Access Compliance Report Public Rights-of-Way (Pedestrian Signals)

Main Street: KELLOGG_DR Cross Street: KELLOGG_DR Location: N

ADA ID: SGAT210922100815 Signal Type: One Push Button-Non APS Overall Compliance: No Severity Scores: BTN 1: 35 BTN 2: N/A No BTN: N/A

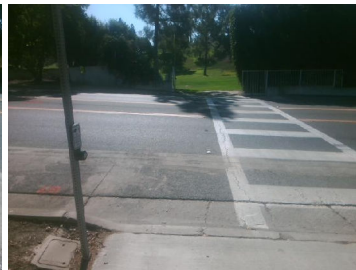
OC Std/PROW: R404.1, MUTCD 4e.08

Possible Solutions: Replace Signal Push Button With APS Button. Provide Clear Space.
